PLAN OF PROPOSED CHAWL No 1

ON PLOT No 4 K. SHEET E. II

GARDEN QUARTER

MEMO

PLAN OF PROPOSED CHAWL

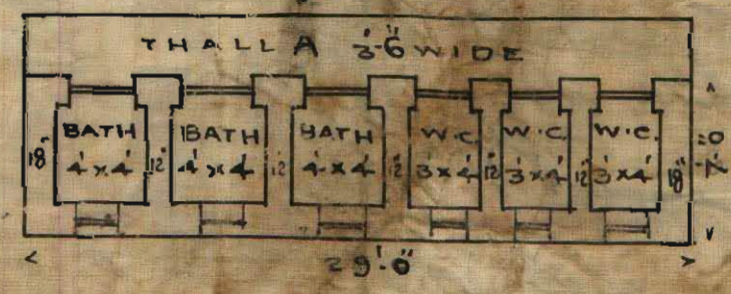
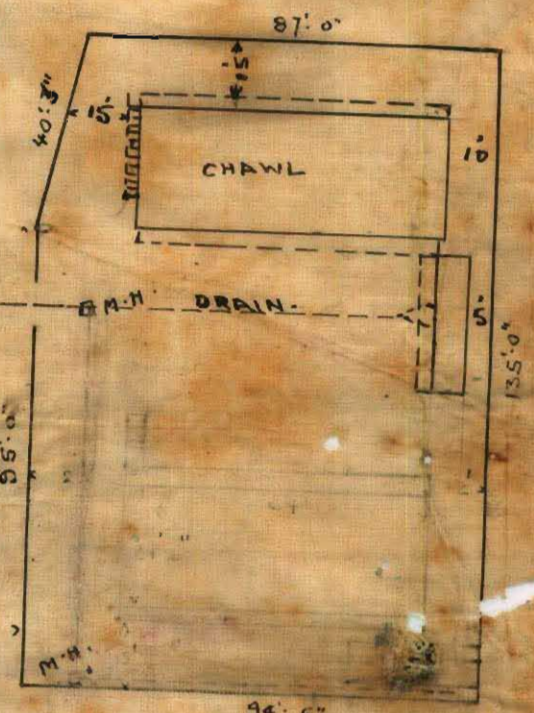
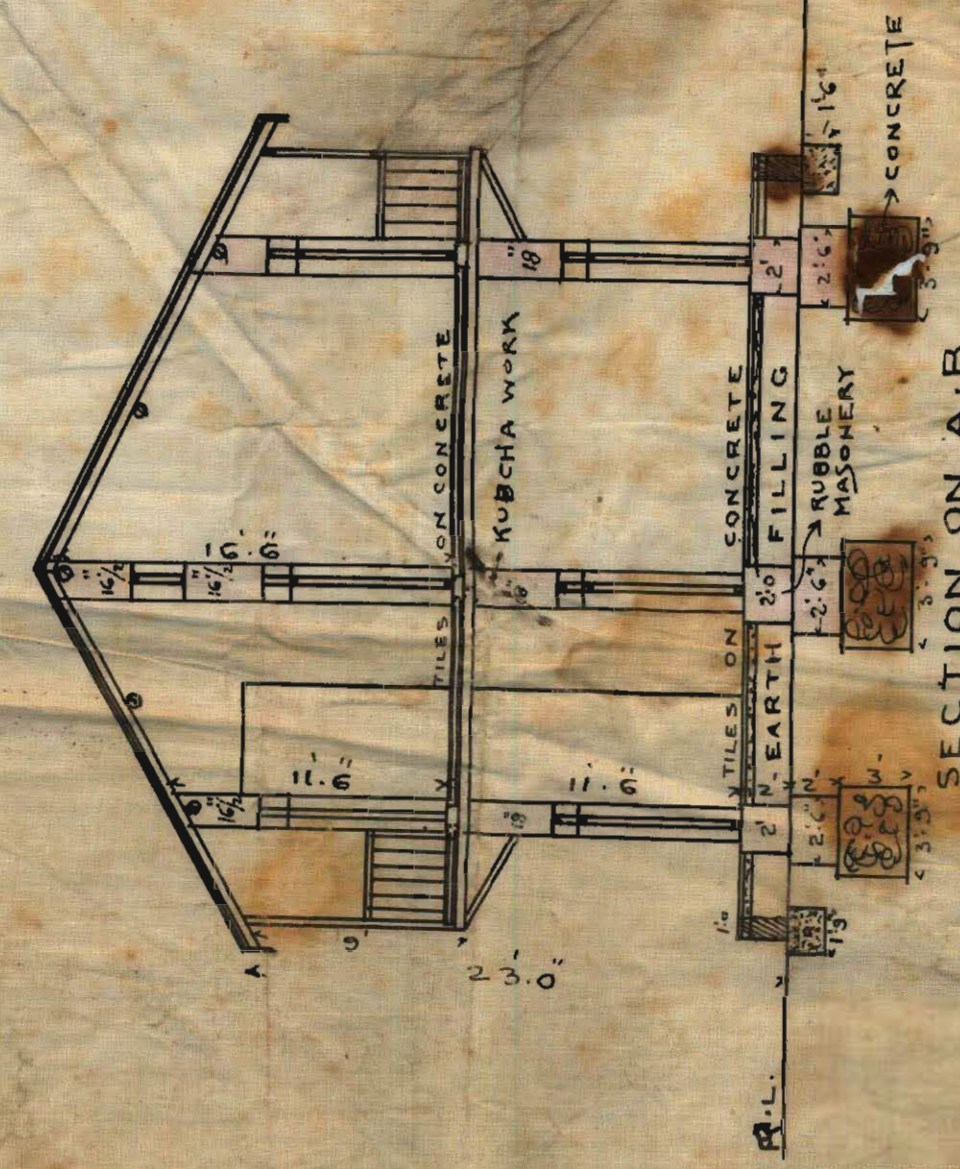
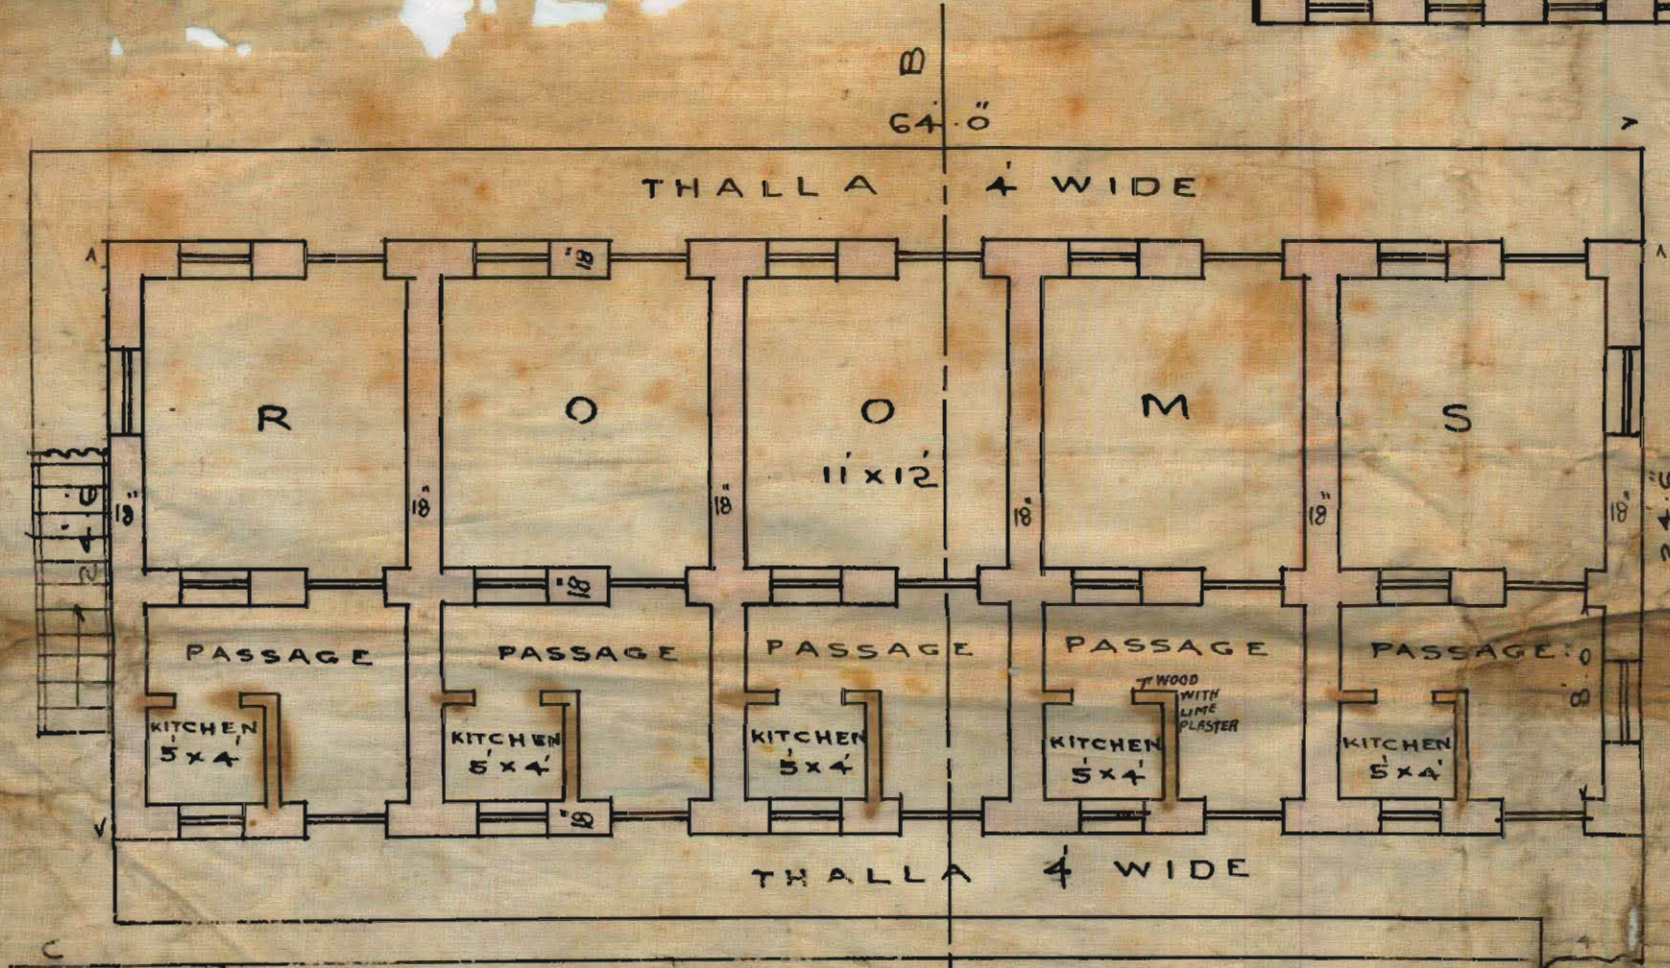
With reference to the plans submitted by ^{them} him on 12th instant for building on plot No. 4K, E-11 Garden Quarter Messrs Dayaram Gordhandas and Issardas Assanmal are informed that not more than 1/4th of the area of the plot will be allowed to be built on.

Only one building will be allowed on a plot of less than 2000 square yards area in this quarter.

All buildings must be set back to at least 10'-0" from the compound walls.

It must be shown on the plan how ^{they} proposes to connect ^{the} in^{ter} Cs. with the drainage system.

It is not clear if the
applicant is going to
connect his premises with
the drainage. If so, it
will be necessary to show
on the plan how the
connection is to be made.
